ORDER UNDER SECTION 96 (2) OF ACT, III OF 1901.

Mr. Baola K. Luma is informed that the plan submitted by him for building a chawl on plot No. 2A/2 Survey Sheet S.4 situate in Street, Garden

AMENDED PLAN OF PROPOSED CHAWL
TO BE BUILT ON SURVEY NO 2A
SHEET 1-14 GARDEN Q R

PLAN SHOWING PROPOSED CHAWL TO BE BUILT ON PLOT NO. 2A/2
SHEET 14, GARDEN QUARTERS
SCALE 8"=1'

DRAWING NO 25

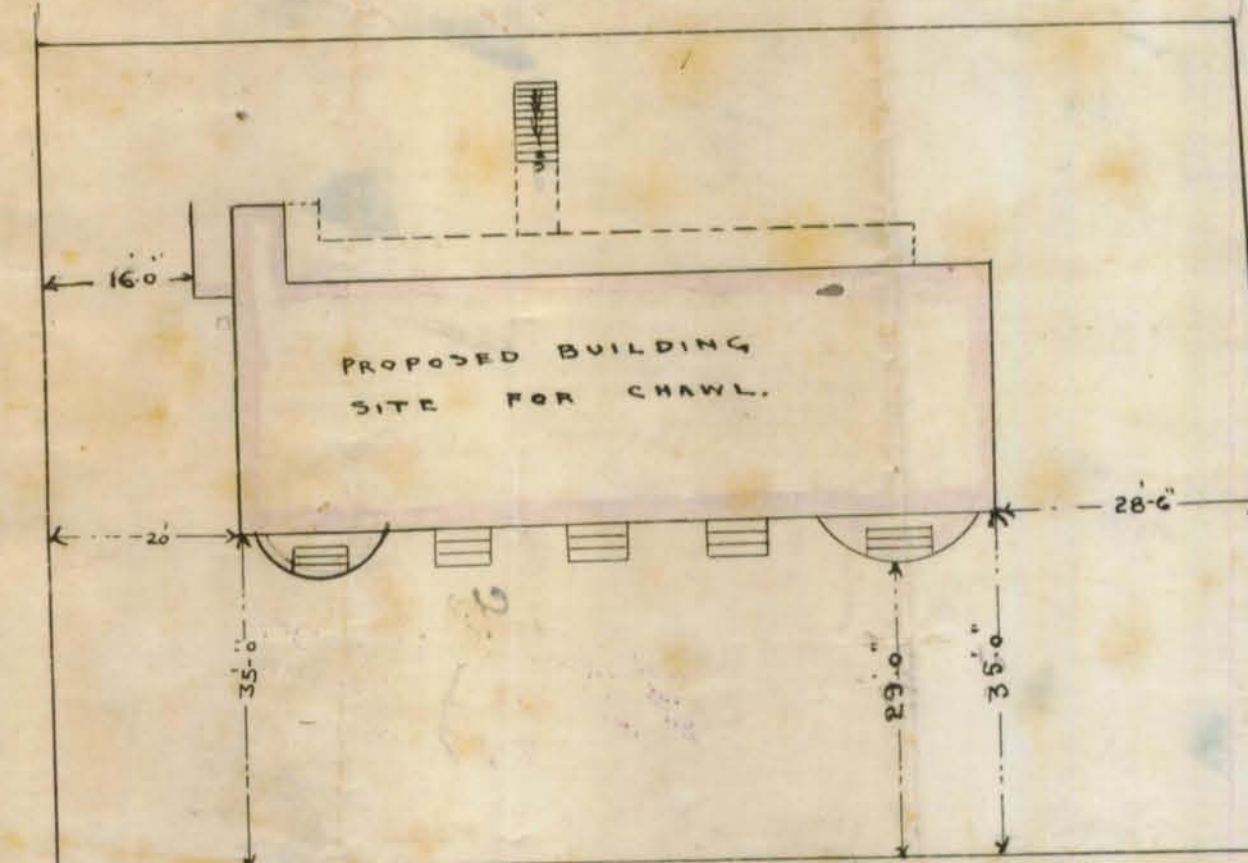
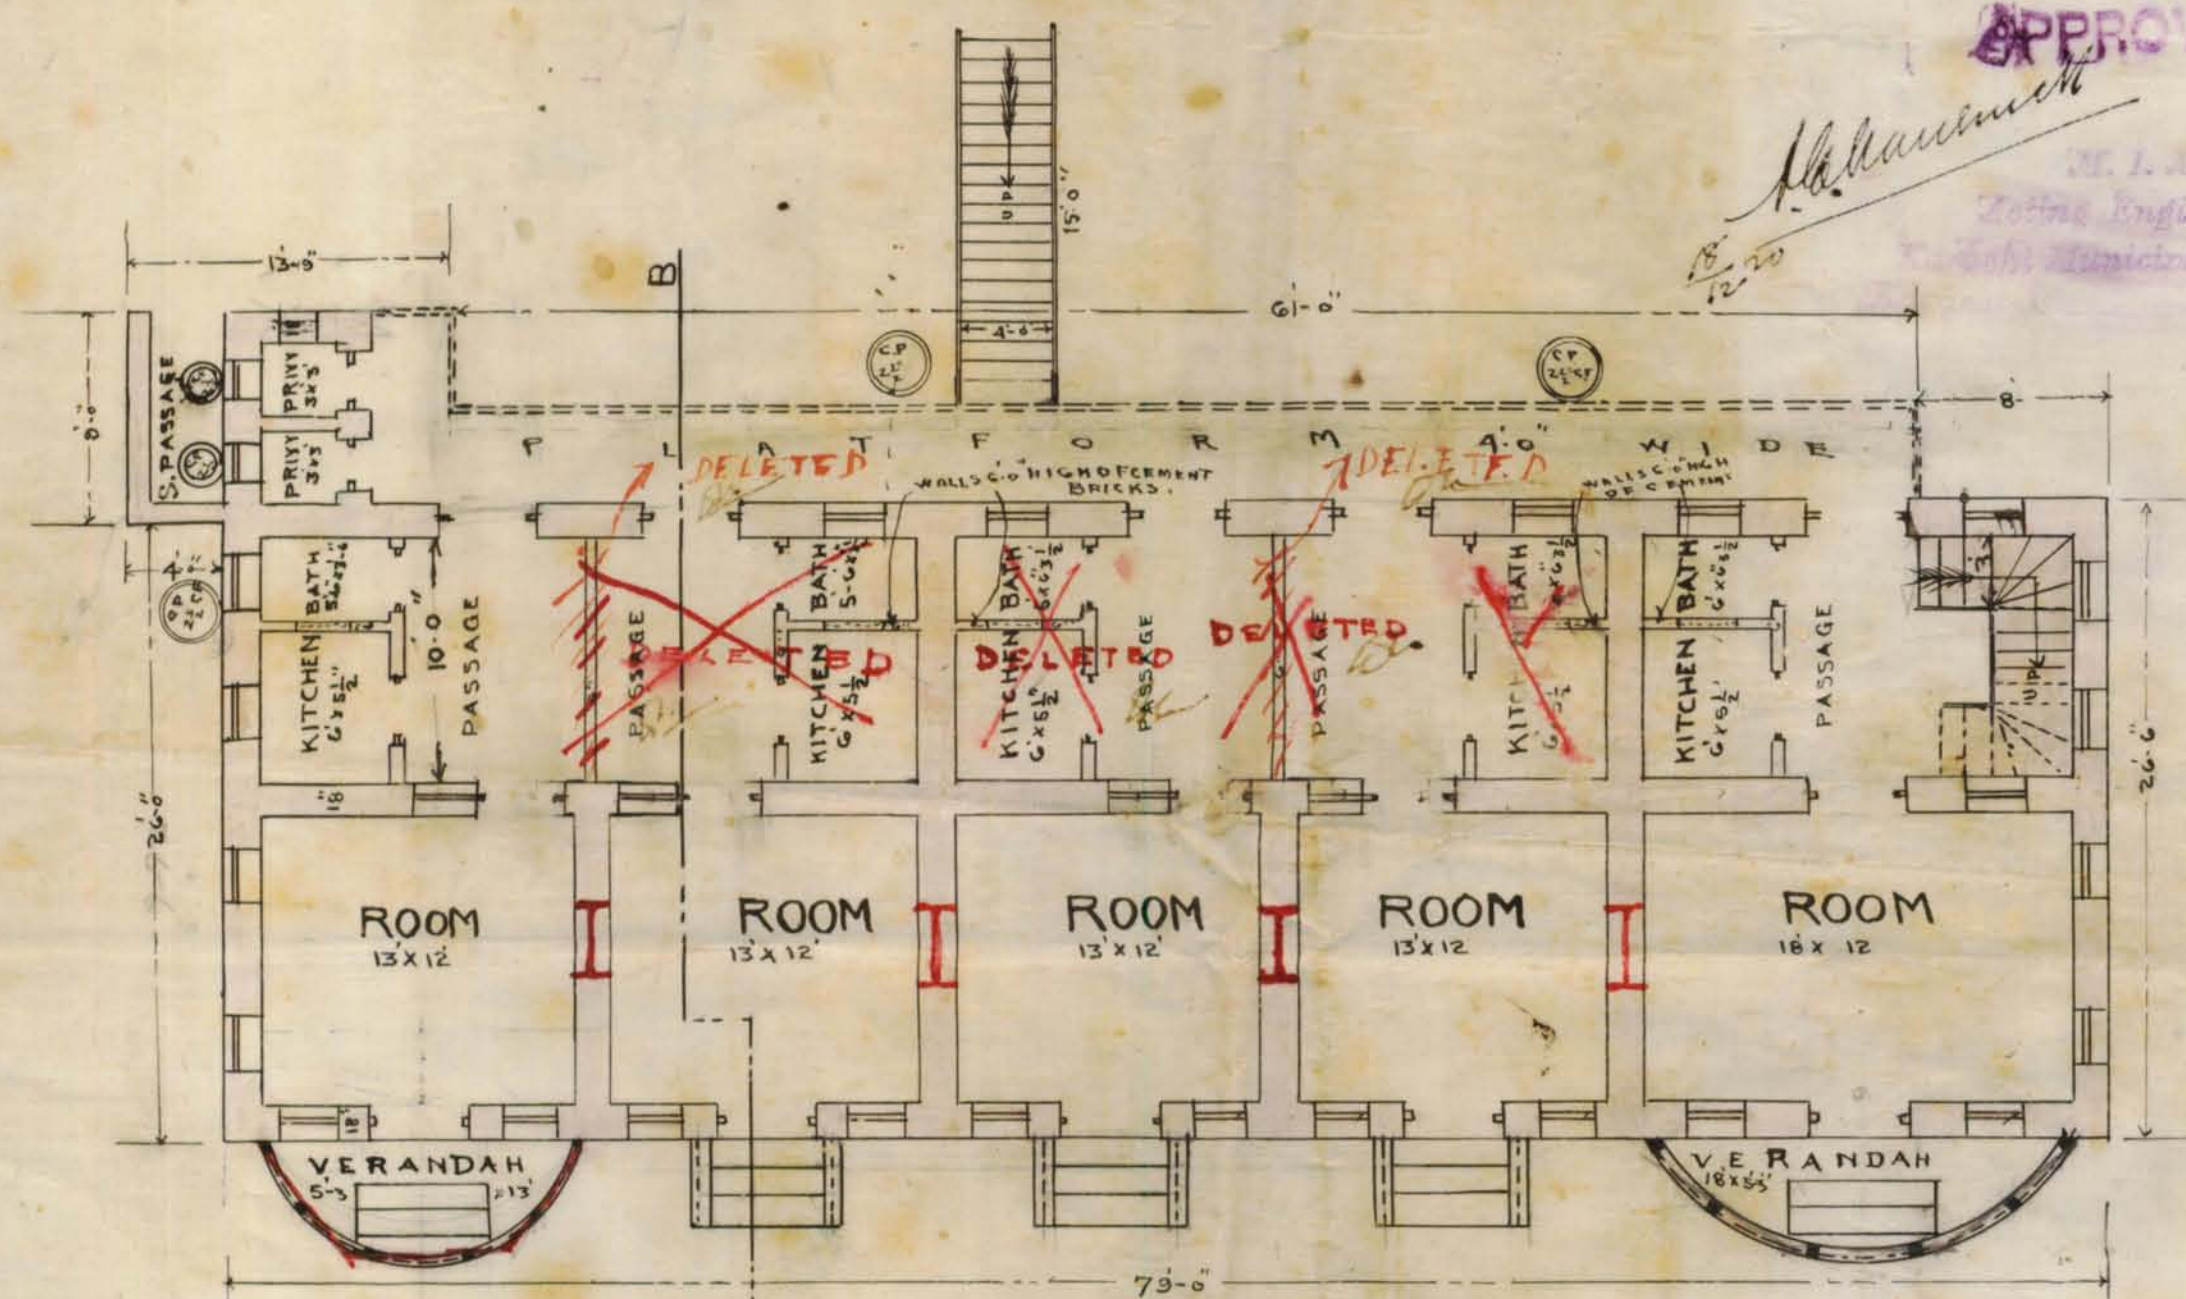
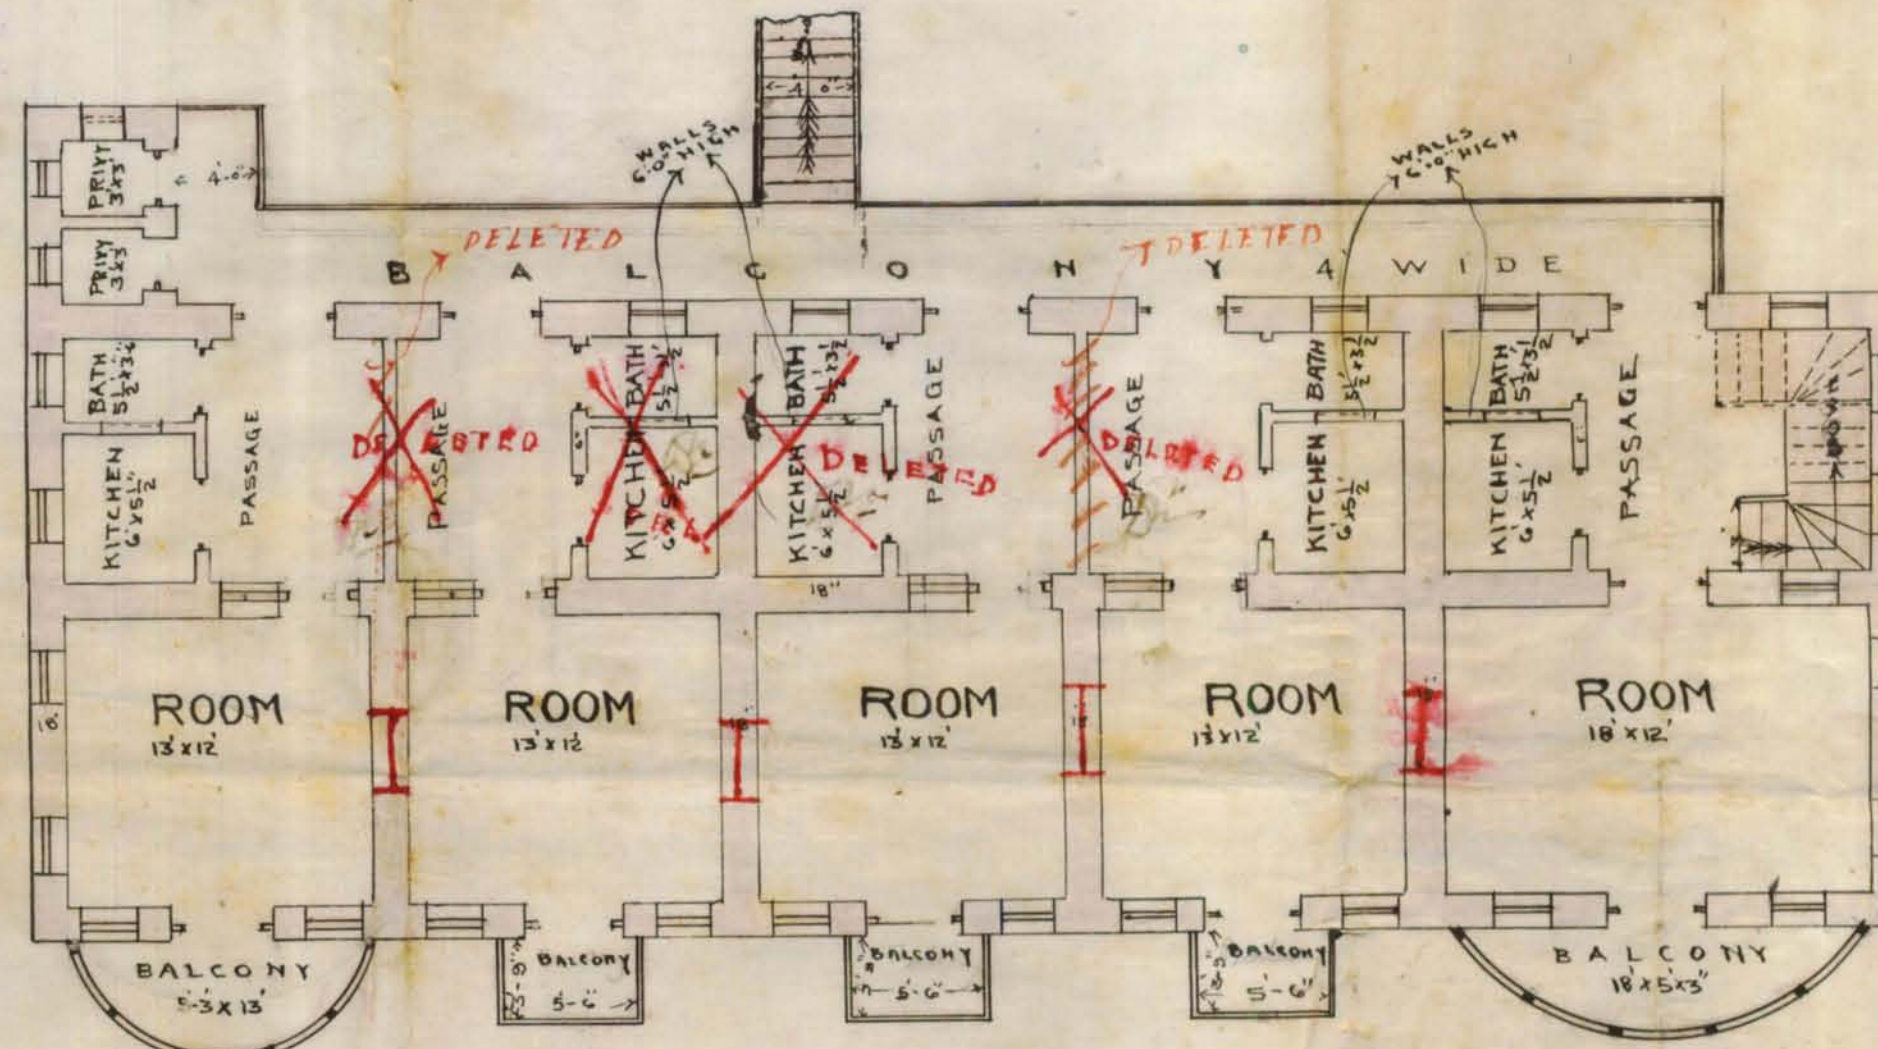
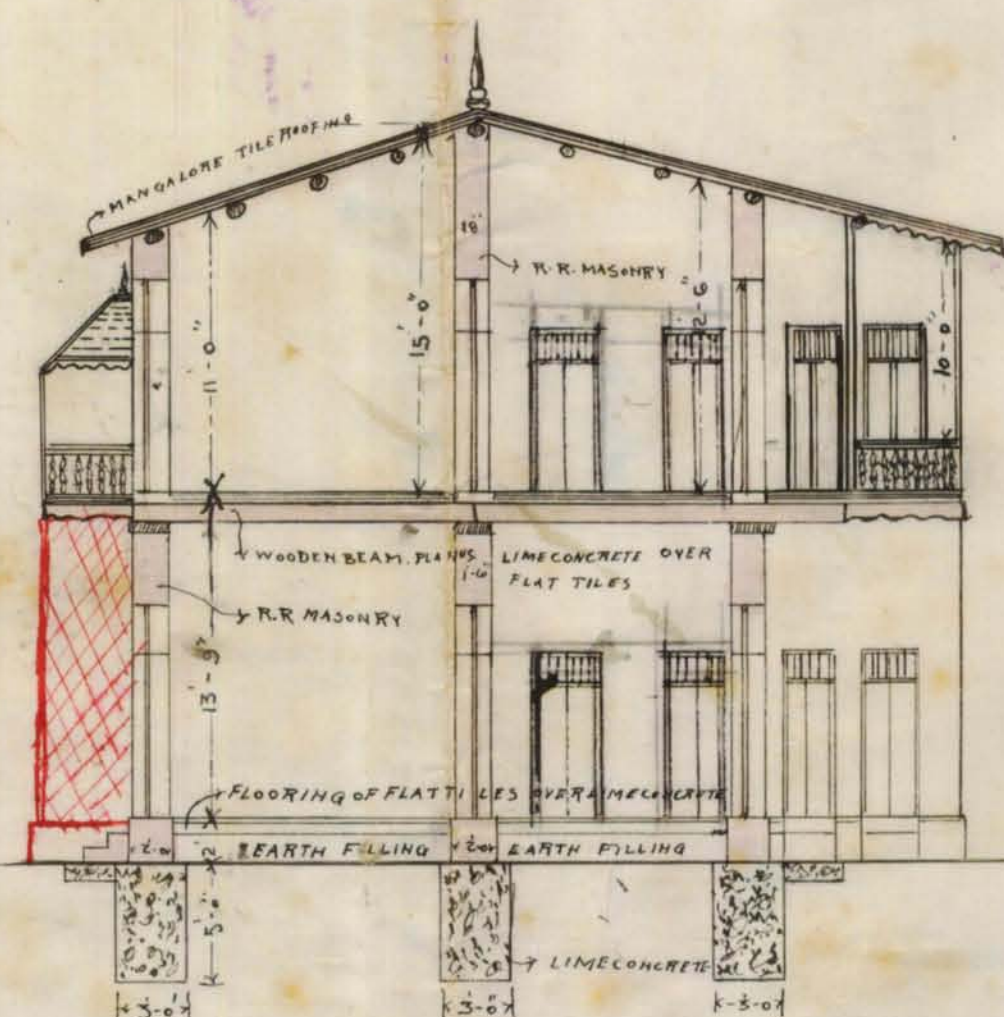
With ref. to his letter dated 24th Sep 20.
^{amended}
The letter ^{amended} plans for the proposed building
under construction on Plot No. 2A/2 F. 4
Garden Dr., Mrs. Bhoolab Khuria is
informed, the elevation on the blue print
copy does not tally with that of the
tracing copy.

Submitted to the report
there is now no objection
in approving the plan.
(Blue Elevation of blue print
copy to be corrected similar
to tracing copy).

Privy accommodations
 is not adequate

up & stray objects
 & one room tenements
 in garden district. It
 must be advisable
 to consult the City
 Dept collector who

Corrected as required

Forwarded to the HO
 on basis of report, the
 single tenements have been
 deleted
